CITY OF CARMEL-BY-THE-SEA PLANNING COMMISSION

REGULAR MEETING Wednesday, September 13, 2023

TO:	Chair LePage and Planning Commissioners
SUBMITTED BY:	Evan Kort, Associate Planner
APPROVED BY:	Brandon Swanson, Community Planning & Building Director
SUBJECT:	DS 23-022 (Bellasis): Consideration of a Final Design Study, DS 23-022 (Bellasis), and associated Coastal Development Permit for a 716-square foot addition to an existing one-story single-family residence, including a new 509-square-foot second story located at 4th Avenue 2 northeast of Lobos Street in the Family Residential (R-1) Zoning District. APN: 010-013-004-000.

Figure 1. Color scheme presented at May 10, 2023 hearing.

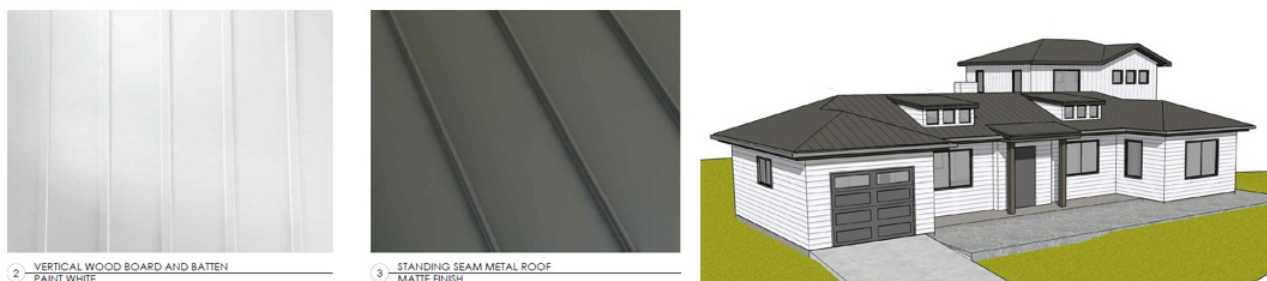
- 4. Building Color - A.** Prior to scheduling for final details review, the applicant shall revise the color palate for the residence using the Residential Design Guidelines
- 5. Building Color - B.** Prior to scheduling for final details review, the applicant shall identify the color (manufacture and color name) for the proposed color identified in Condition

Figure 2. Color scheme presented at June 14, 2023 hearing.

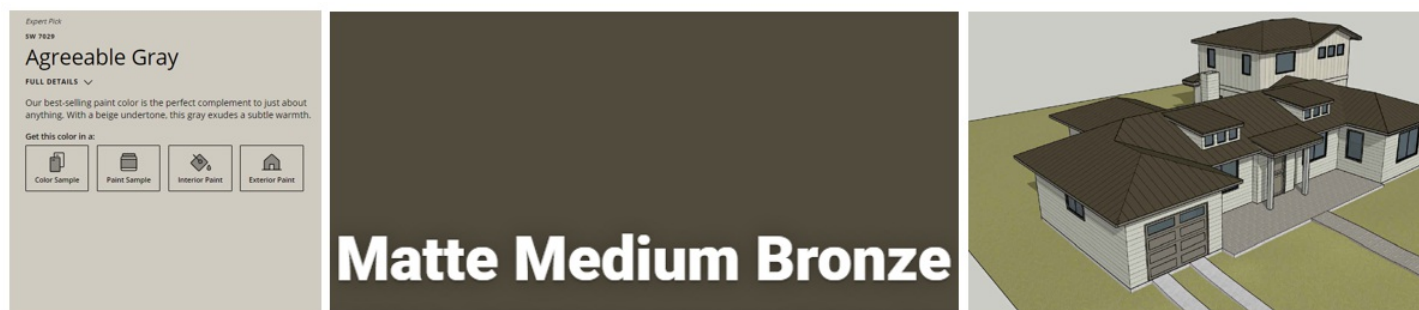
At the June 14th hearing, the applicant presented an alternative color palate for the residence consisting of an “Agreeable Gray” body color, and a “Matte Medium Bronze” requested feedback regarding the proposed color palate and the commission did not include any draft condition to change the color and appeared supportive of the proposed color.

Figure 1. Estimated area of the courtyard/open space. No surveys of the subject site exist. Plans on file include some dimensions but do not appear to be accurately scaled –therefore, the total square footage is estimated based on the dimensions provided.

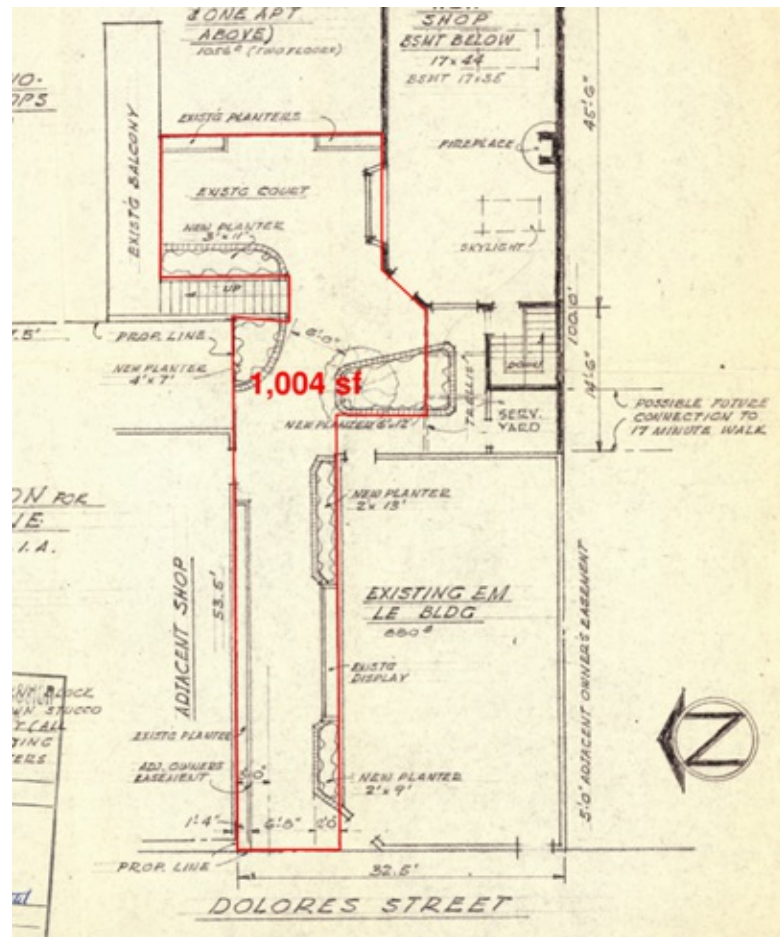
1. The subject property is 4,994 square feet and staff estimates the combined area of the courtyard and open space area to be approximately 1,000 square feet (see Figure 1, below). Based on these figures, the outdoor seating area could be no more than 300 square feet (30% of the courtyard), as this is the lesser of the two standards.

The applicant has indicated the seating area is 127.5 square feet (refer to attachment 3), however, this figure only appears to represent the area of each individual table and chair, and not the full demarcated area described in Section 4, below, and could be calculated using a

bounding box around the seating area and not the aggregate area of each table.

Figure 2. Existing outdoor seating viewed from sidewalk adjacent to Dolores Street.

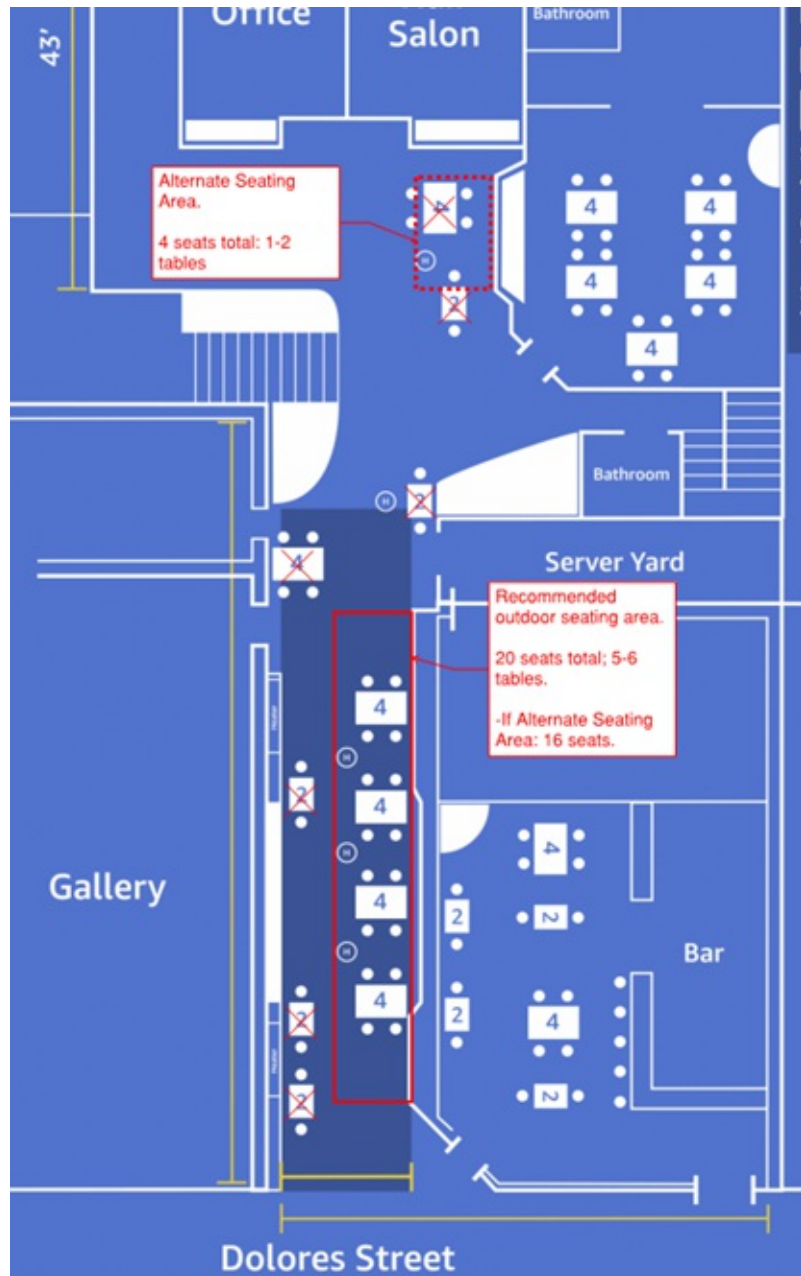
The applicant is proposing to install new electric heaters to be attached to the roof eave of the adjacent building which would serve the located under located on the north side of the walkway/courtyard (left side of Figure 2, above). However, as discussed in Section #4, staff is recommending the total number of seats be reduced and all seating be relocated to the south side of the walkway/courtyard.

Outdoor Seating Summary: In summary, staff recommends the Commission partially grant approval of the expansion of the outdoor seating area. Staff recommends an increase of the outdoor seating from eight (8) seats to twenty (20) seats split between 5-6 tables located along the northern wall of the existing restaurant building (with an alternative consideration for some tables to be located at the north wall of the new dining room).

Figure 3. Existing and proposed partial top floor plans. Existing (left) shows overlay of 12 square foot addition.

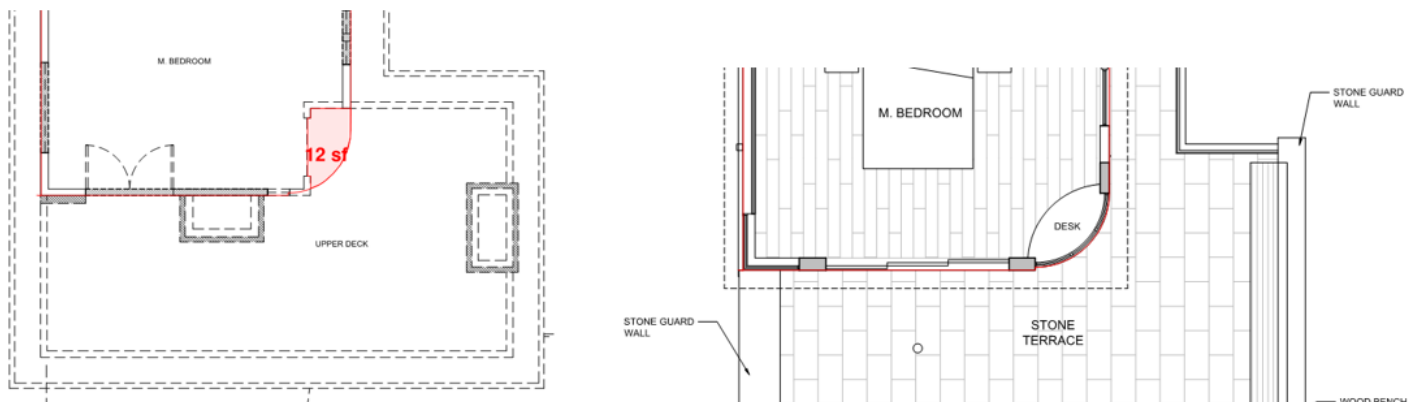
Though the resulting building is decreasing in mass as a result of the removal of the architectural forms, the applicant is proposing an addition to the uppermost level of the residence. This addition results in an increase of 12 square feet of floor area on the top level. While a small addition is likely negligible in term of visual impacts, this increase in floor area cannot be permitted as the existing residence is already non-conforming in respect to floor area and the addition would be above the 18' height limit prescribed for the Beach and Riparian (BR) Overlay District.

Figure 5. Proposed retaining wall and fence at 12th Avenue walkway. Section and Rendering.

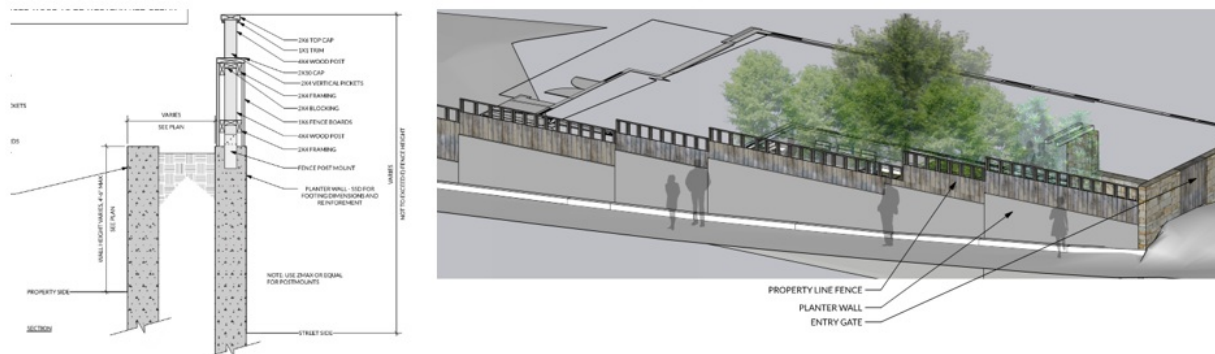
The new fence along the 12th Avenue walkway is proposed to be constructed above a concrete retaining wall with the intention to match the existing fence height. While the plans appear to lack sufficient detail (grade not shown and varying height noted), the concrete retaining wall appears to be approximately 3'6" tall with based on elevation points provided on the landscape plan and the topographic survey provided in the plans. The wood fence would then be located on-top of the retaining wall to match the height of the existing fence.

As measured from the public walkway, the existing fence varies in height with the solid portions of the fence varying between approximately 72"-85" above the adjacent curb of the walkway for those portions of the fence not located in the front setback along Scenic Road (72", or 6' is allowed for a fence within the side setback). In accordance with CMC 17.10.030.E.1, the Planning Commission may authorize taller fences in side or rear yards, however, height limits for fences or walls within the front setback may not be altered through Design Review. However, CMC 17.10.030.E.2, states that *"Existing fences and walls may be rebuilt if damaged or deteriorated without conforming to current height limits upon submittal of plans and photographs documenting existing heights and materials prior to demolition. The director may approve the rebuilding as long as heights are not increased."*
